Groundwater Monitoring Bore Drilling Project at Merriwa:

Review of Environmental Factors Addendum

May 2014

Figure 2-1 Amended Drill Site Layout

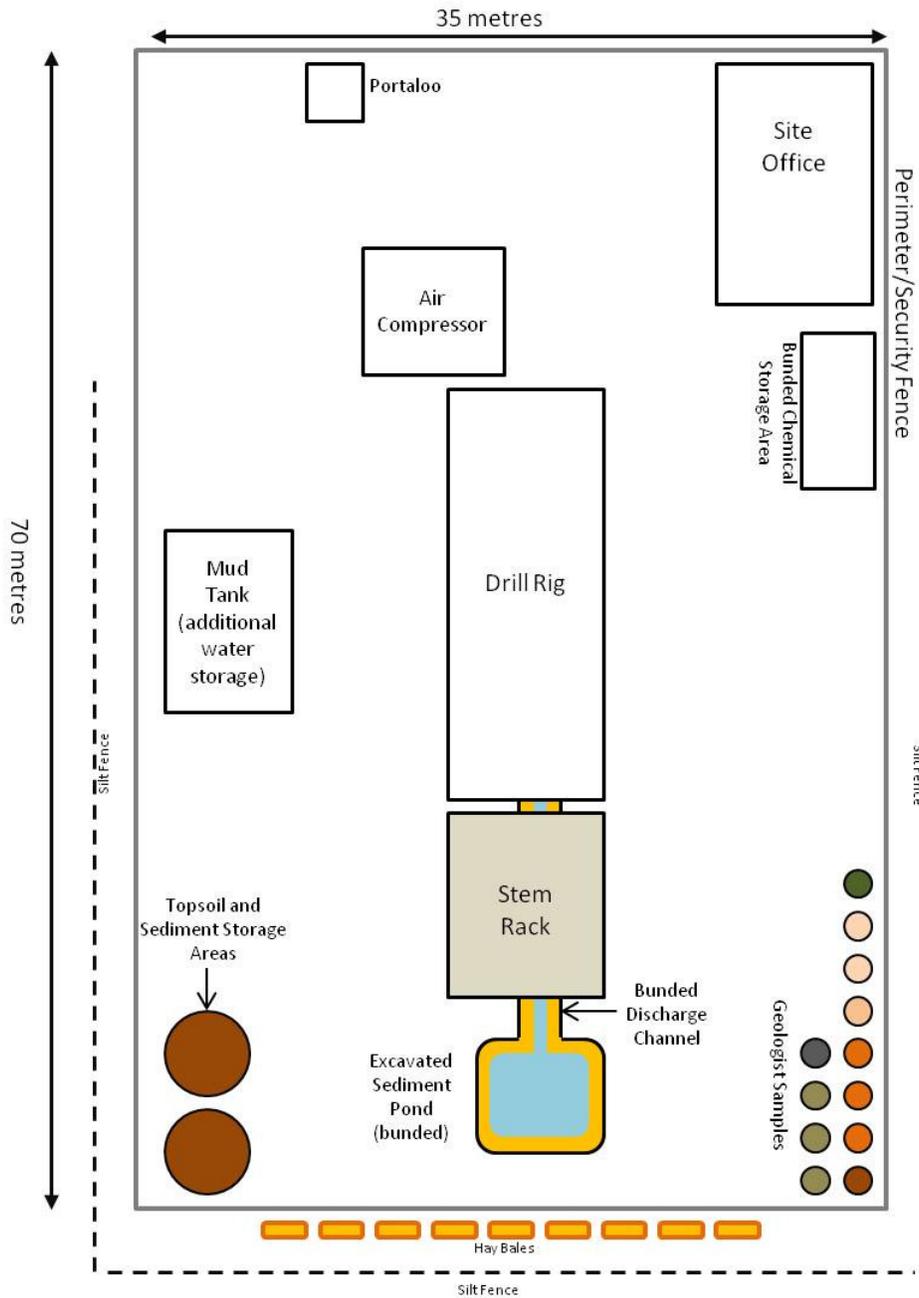
The new drilling rig will be a Mole Pioneer 250 rig. This will replace the Bournedrill 350 THD rig. Air rotary drilling is similar to mud rotary, except that the mud pump is to be replaced by a compressor assembly (which includes a cooling system, air receiver and unloading system). Air is forced through the drilling pipe and into the rotary drill bit. Air drilling is generally used in hard clay or rock formations.

The blow-out protection (BOP) cellar and flare pit will no longer be required. The new drill will require an air compressor and two extra pits, each measuring 25m³. These pits will be lined and will retain the excess water before it is disposed. The site layout also includes a mud tank which will only be used if large quantities of wastewater are encountered.

There will be no change to the overall site footprint.

The amended drill site layout is displayed in Figure 2-1 below.
